Access Compliance Report

Public Rights-of-Way

Intersection ID: 45174	Main Street: LINDEN_TREE_LN	Cross Street: SOCIETY_ST	Location: SW
ADA ID: D030B965207B	Ramp Type: Perp	Initial Pass/Fail: Fail	Overall Compliance: No
		Severity Score: 25

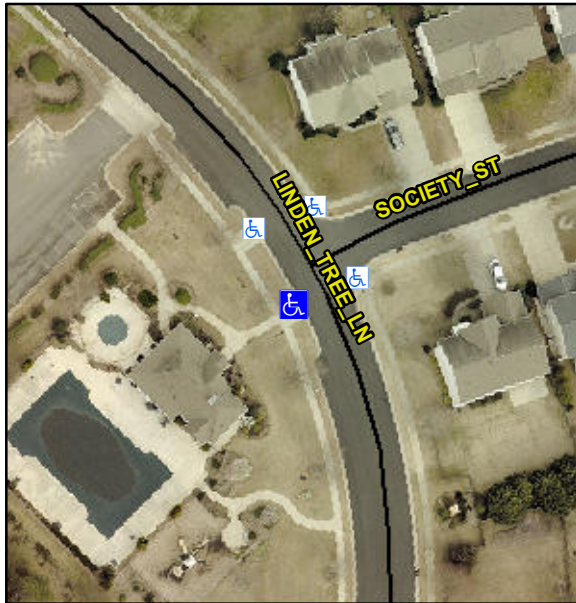
Not Found, R304.2.2, R304.5.3

Compliance	Description	Data	Compliance	Description	Data
N/A	Ramp Length (in)	112.0	No	Ramp Slope (%)	8.4
Yes	Ramp Width (in)	59.0	No	Ramp XSlope (%)	5.2
N/A	Flare Type LT	N/A	N/A	Flare Type RT	N/A
N/A	Flare Slope LT (%)	N/A	N/A	Flare Slope RT (%)	N/A
N/A	Flare Traversable LT?	N/A	N/A	Flare Traversable RT?	N/A
N/A	Landing Length (in)	N/A	N/A	DWS Provided?	N/A
N/A	Landing Width (in)	N/A	N/A	DWS Contrast?	N/A
N/A	Landing Slope (%)	N/A	N/A	DWS Length (in)	N/A
N/A	Landing X Slope (%)	N/A	N/A	DWS Full Width?	N/A
N/A	Landing Curb? (Y/N)	N/A	N/A	DWS Offset (in)	N/A
N/A	Shared Landing?	N/A			
N/A	Gutter Ponding?	N/A	N/A	Gutter Slope (%)	N/A
N/A	Gutter Lip Ht (in)	N/A	N/A	Gutter X Slope (%)	N/A
N/A	Painted X Walk1?	No	N/A	Painted X Walk2?	N/A
	X Walk 1 Direction	To NE		X Walk 2 Direction	N/A
N/A	X Walk 1 Width (in)	N/A	N/A	X Walk 2 Width (in)	N/A
	X Walk 1 Slope (%)	1.6		X Walk 2 Slope (%)	N/A
	X Walk 1 X Slope (%)	1.9		X Walk 2 X Slope (%)	N/A

Remove & Replace Entire Ramp.
